## Appendix S: Other Concepts Considered

# I-95/I-64 Overlap Study

Figure S1

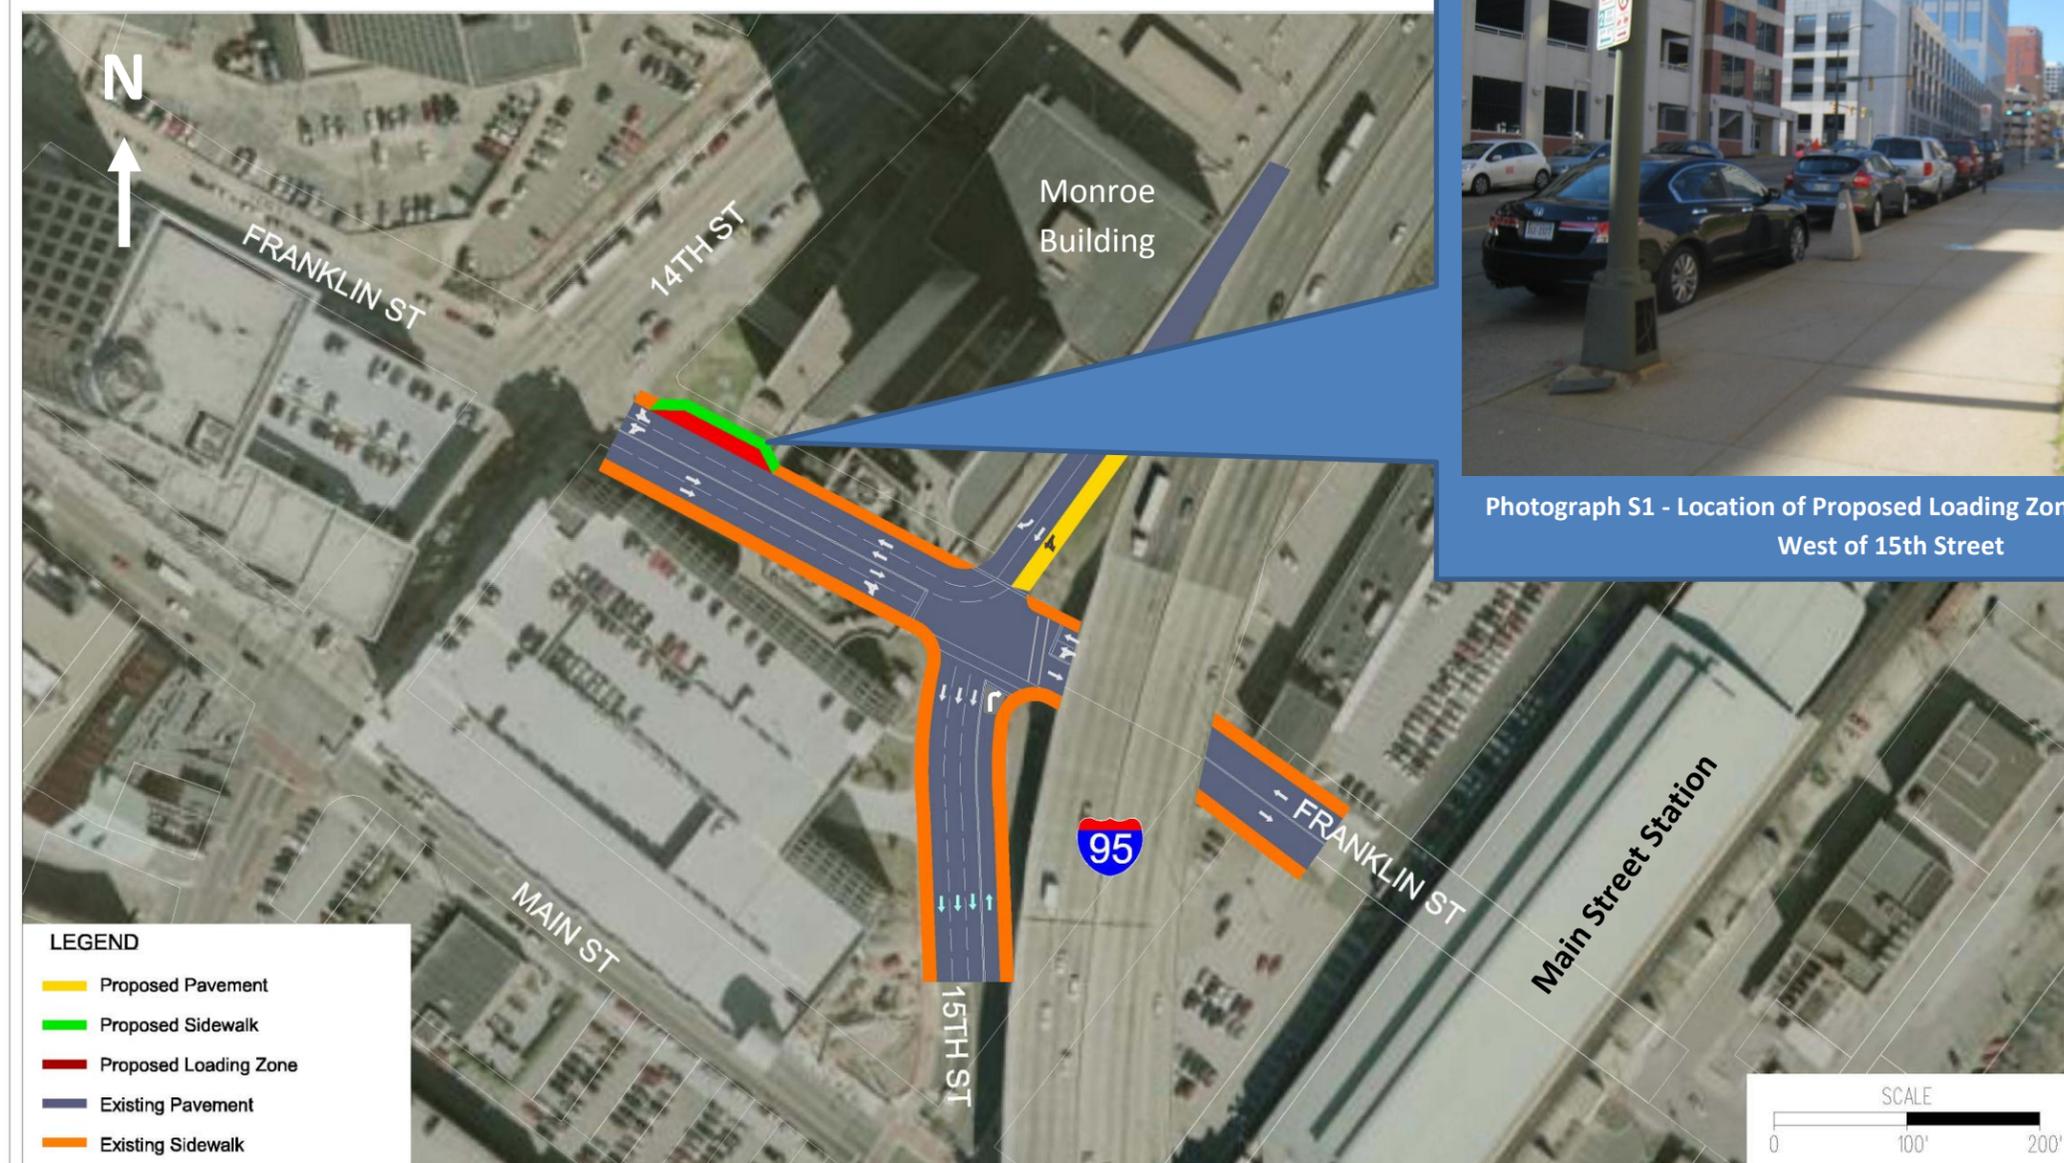
The final Franklin Street area Six-Year Improvement Program (SYIP) projects agreed to by the study team are shown in **Section 6.2** under SYIP #7. Improvements 1 – 3 described in **Table S1** were proposed in addition to the final SYIP projects at Franklin Street; but were eliminated during the screening process. These improvements were specifically developed to mitigate issues 4 and 5 defined below. Proposed improvements 1 – 3 were eliminated based on the operational and safety concerns summarized in **Table S1**:
